**Number:** V2500-NAC-71-0283

**SUBJECT:** PYLON APRON - NO. 1 HINGE BEAM - MODIFICATION OF AND REPLACEMENT OF  
ATTACHING HARDWARE - FAN CASE ATTACH BRACKETS - MODIFICATION OF

"MODIFICATION SERVICE BULLETIN" - "NACELLE - PYLON APRON - NO. 1 HINGE BEAM -  
MODIFICATION OF AND REPLACEMENT OF ATTACHING HARDWARE - FAN CASE  
ATTACH BRACKETS - MODIFICATION OF"

Fan Cowl #1 Hinge Beam Installation Modification  
Figure 1 (sheet 2)

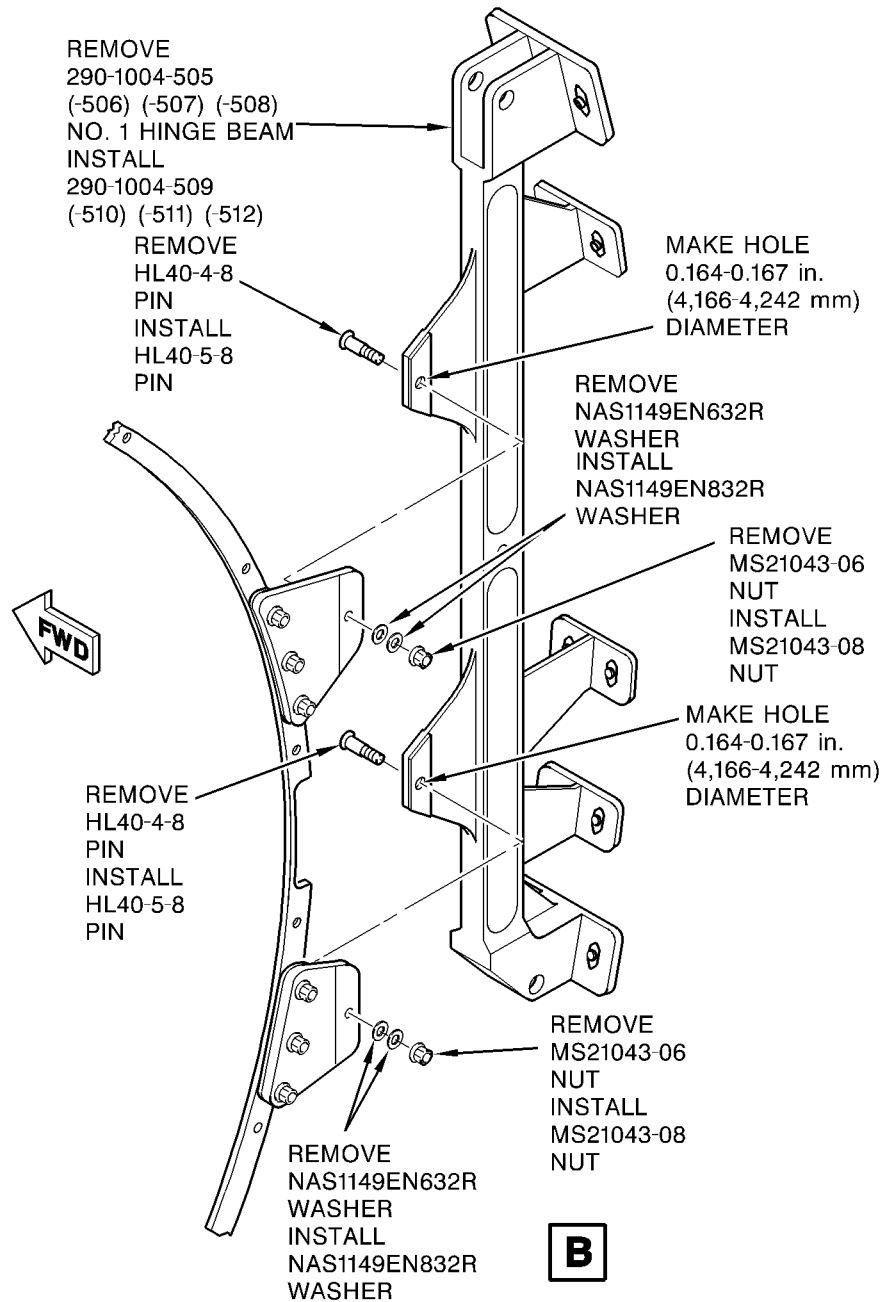
- A. Remove the No.1 hinge beam from the fan case attach brackets. Refer to Figure 1 (sheet 2).

(1) Remove the MS21043-06 nuts, NAS1149EN632R washers, and HL40-4-8 pins that attach the No.1 hinge beam to the fan case attach brackets. Discard the pins, nuts, and washers.

- C. Make the holes in the brackets and the hinge beam larger. Refer to Figure 1 (sheets 2 and 3).

(1) Make the holes in the brackets and No.1 hinge beam 0.164 to 0.167 inch (4,166 to 4,242 mm) diameter.

F. Install the No.1 hinge beam on the brackets. Refer to Figure 1 (sheet 2).

(1) Apply primer mix to the hinge beam attach hardware to provide dissimilar metal protection.

(2) Install the hinge beam on the brackets with the new HL40-5-8 pins, NAS1149EN832R washers, and MS21043-08 nuts.

Fan Cowl #1 Hinge Beam Installation Modification  
Figure 1 (sheet 2)

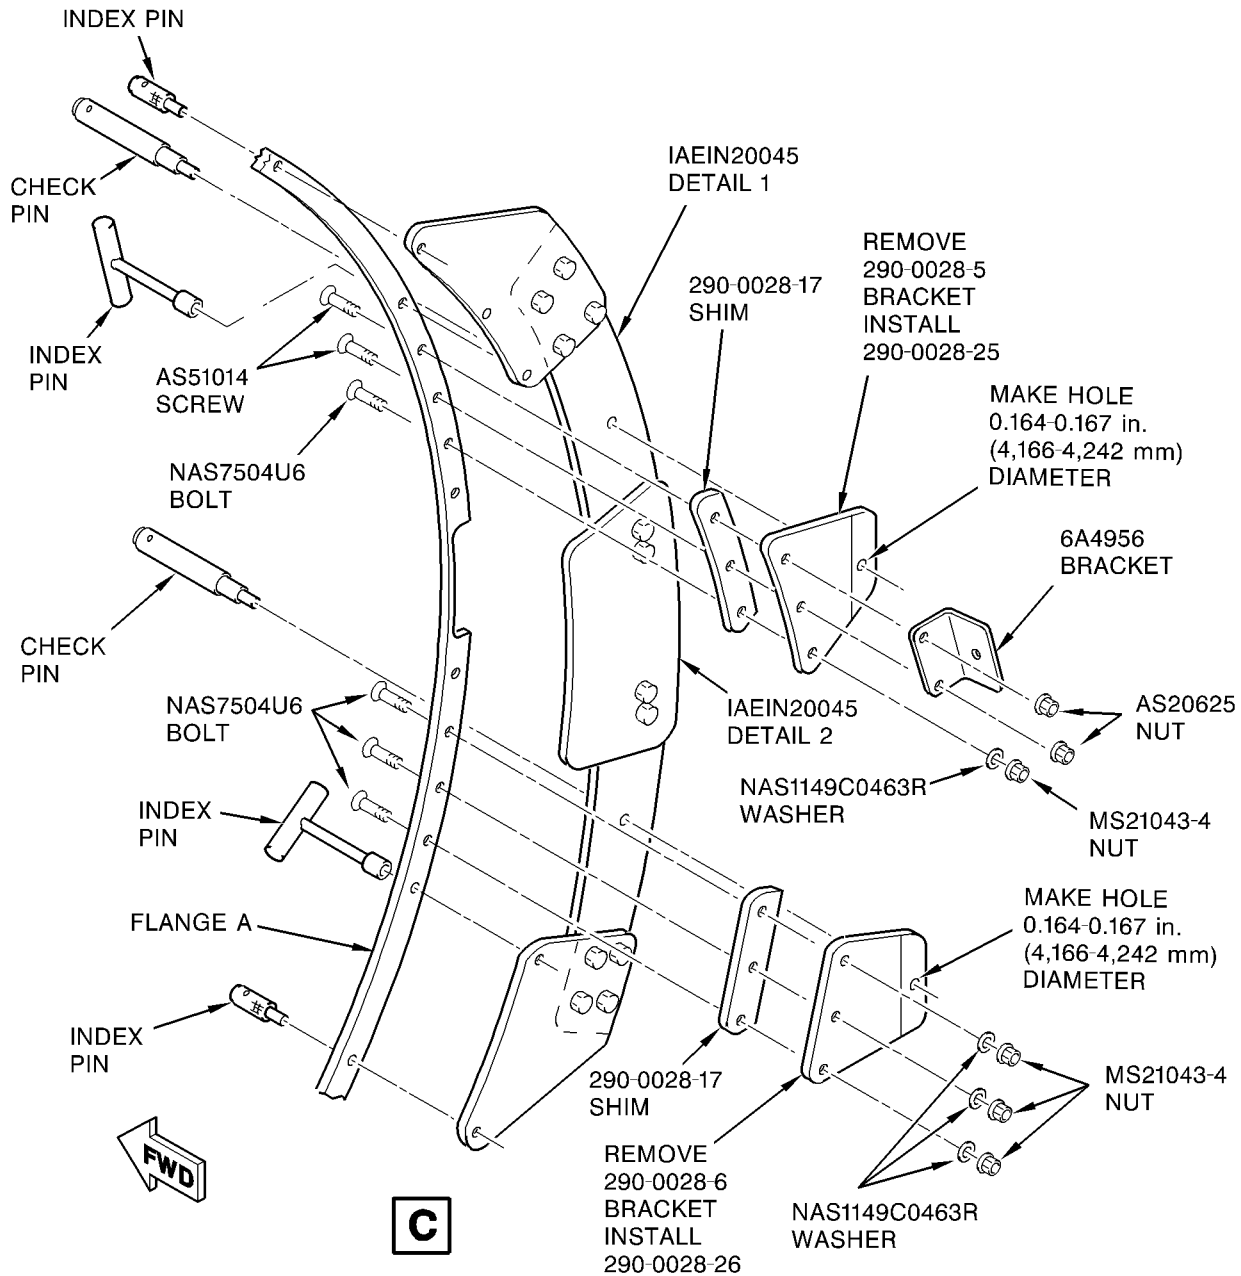
- B. Remove the brackets from the fan case (if necessary for access). Refer to Figure 1 (sheet 3).

NOTE: The alignment of the brackets on the fan case is critical to proper installation of the hinge beam. If you remove the brackets from the fan case, you will have to use the IAE1N20045 tool to install them.

(1) Remove the nuts, washers, and bolts that attach the brackets and shims to the fan case.

E. Install the brackets (if removed). Refer to Figure 1 (sheet 3).

- (1) Remove the hardware from the Rolls-Royce bracket at flange A, Holes 29 and 30. Move the bracket and tube aside to make room for the IAE1N20045 tool.
- (2) Attach detail 1 of the IAE1N20045 tool to the aft side of flange A with four index pins.
- (3) Hold detail 2 of the IAE1N20045 tool to the aft side of flange A with two clamps.

- (4) Mix the catalyst (CoMat 07-139), the primer (CoMat 07-140), and the thinner (CoMat 07-144). Refer to the manufacturer's instructions.
- (5) Apply primer mix to the bracket attach hardware to provide dissimilar metal protection.
- (6) Install the shims and brackets on flange A with the screws, bolts, washers, and nuts.
- (7) Make sure the brackets are in the proper position. Use the check pin.
- (8) Torque the nuts of the screws to 85 to 105 inlbs (10,0 to 12,0 NM).
- (9) Torque the nuts of the bolts to 50 to 70 inlbs (6,0 to 8,0 NM).
